To: Zoning Board of Adjustment
From: Fran Berman
Re: 361 Hanover Street proposal and request for zoning relief
Date: January 21, 2025

Re: 361 Hanover Street Development

The request of 361 Hanover Steam Factory LLC (Owner), and Hampshire Development Corporation LLC (Applicant), for property located at 361 Hanover Street whereas relief is needed to expand and renovate the existing commercial building and convert it to multi-family residential and to construct three new multi-family residential buildings which requires the following: 1) Variance from Section 10.642 to allow residential principal uses on the ground floor of the buildings; 2) Variance from Section 10.5A41 - Figure 10.5A41.10D to a) allow for "Apartment", "Rowhouse" and "Duplex" building types where they are not permitted; b) allow a ground floor height of 10.5 feet where 12 feet is required; and 3) Variance from Article 15 - Definition of Penthouse - to allow a penthouse with a setback of 8 feet from all roof edges where 15-20 feet is required and to allow no greater than 80% of the gross living area of the level of the floor below where 50% is the maximum. Said property is located on Assessor Map 138 Lot 63 and lies

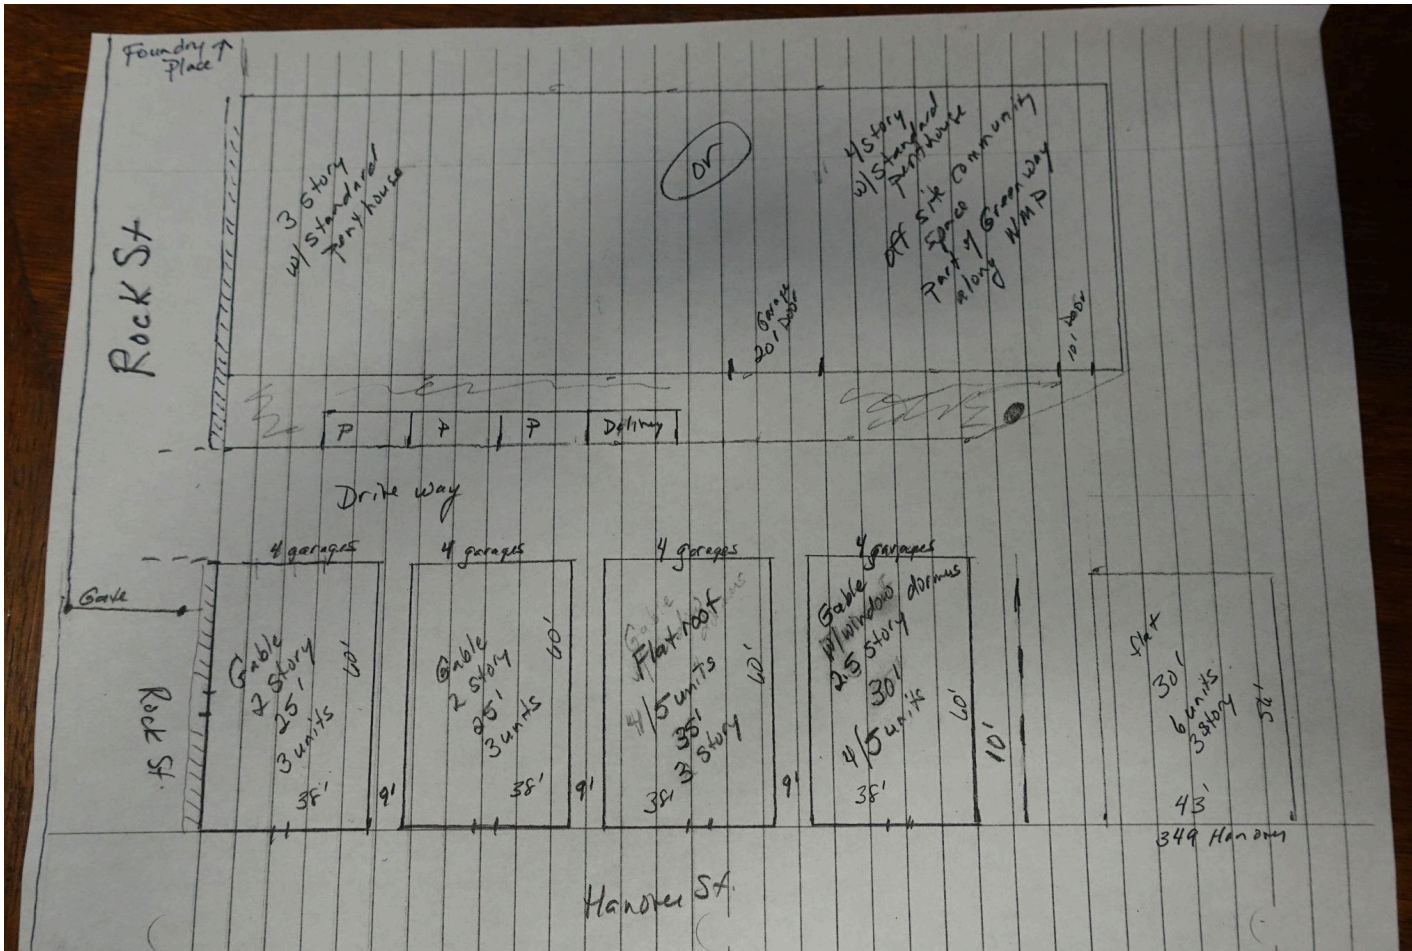
2. I am also concerned about the project's effect on a right-of-way that exists for the residents of 349 Hanover Street to drive through the property at 361 Hanover. This right of way is especially crucial for one of our units, whose parking space abuts 361 Hanover directly, requiring them to maneuver their car through the current parking area at 361 Hanover in order to enter and exit their parking space along the southwestern side of our building. Two additional parking spaces that belong to 349 Hanover are located along the rear of our building on Hill Street and also need access through the right of way. I do not see any references to this right of way in the current proposal. Please see the attached site plan showing the property lines and indicating the affected parking spaces in yellow.

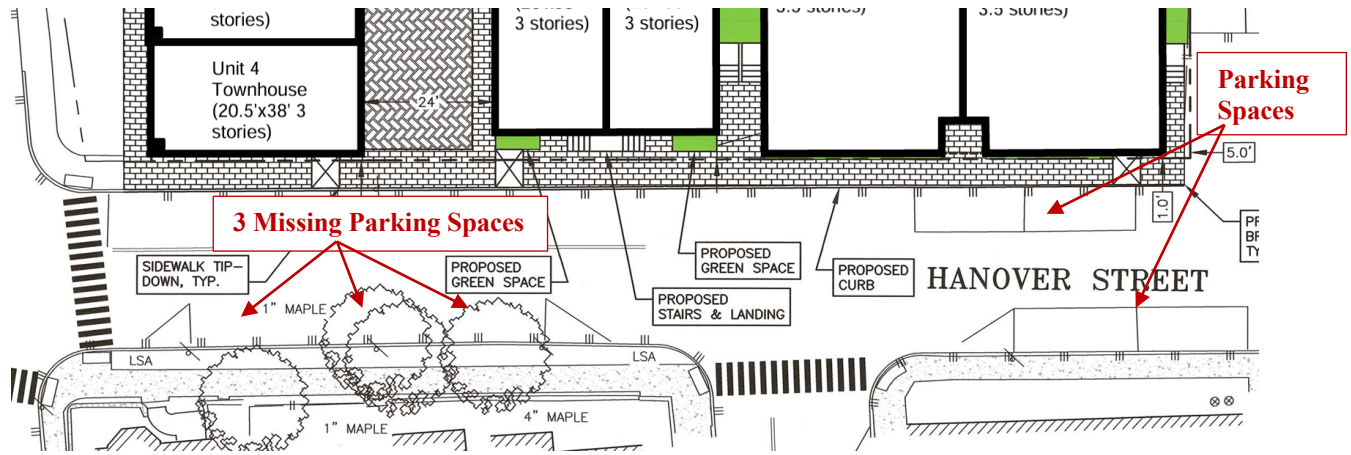
- (3) Applicant shows 26 Units in Building A in this revised plan without the penthouse. Yet, on pages 14 and 52 of their proposal, they show a calculation for Workforce Housing Units “10% of 36 = 3.4 Units = 3 Units”. Firstly, their math is wrong (10% of 36 = 3.6, not 3.4) and secondly, the calculation should now be “10% of 26 Units = 2.6 Units = 2 Units”. Or, are their # of Units in Building A incorrect? Are they still requesting a CUP and providing workforce housing units and community space or has this changed??:

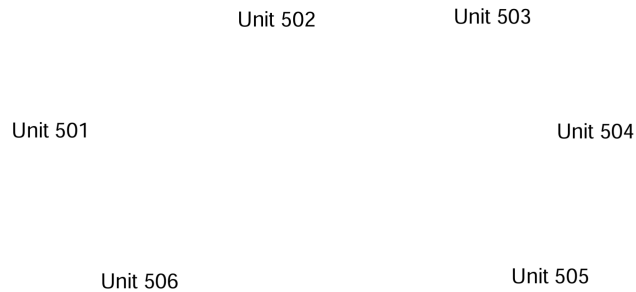
- (4) Also on page 14, The illustration of the property fronting on Hanover Street includes rectangles to show parking spaces. However, they do not show 3 existing parking spaces opposite their new entrance to the property. Does this mean that their new entrance will cause the loss of 3 parking spaces to allow entry/exit to the property on Hanover Street, which is already a parking desert?

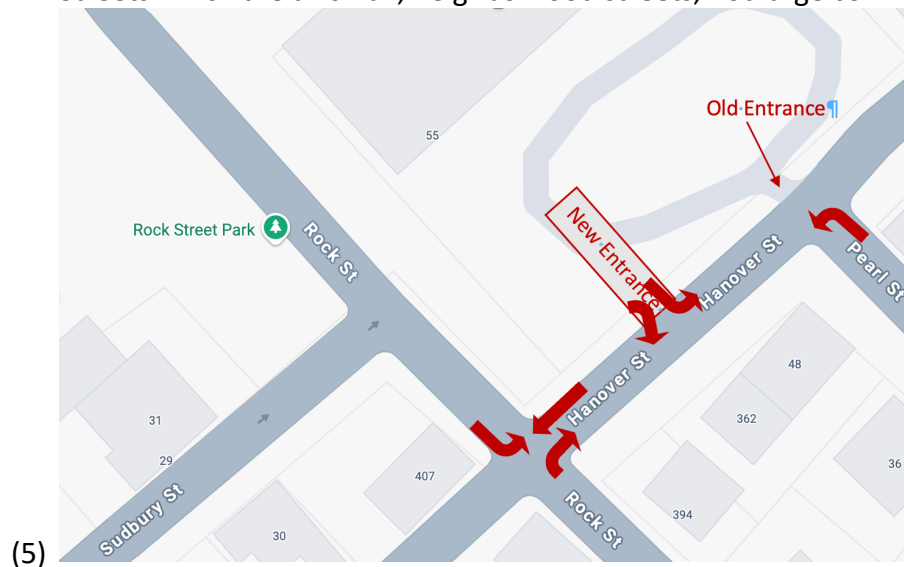
- (1) **Mansard Roofs:** 2 of the buildings on this property have Mansard roofs. None of the houses surrounding this property have Mansard roofs – the roofs which are throughout our neighborhood are Gable Roofs (predominately), Saltbox, and Flat roofs. There are no Mansard roofs. Mansard roofs are out of character with our neighborhood and this is in Character District 5 and should match with the existing character of the neighborhood which the proposed mansard roofs do not.
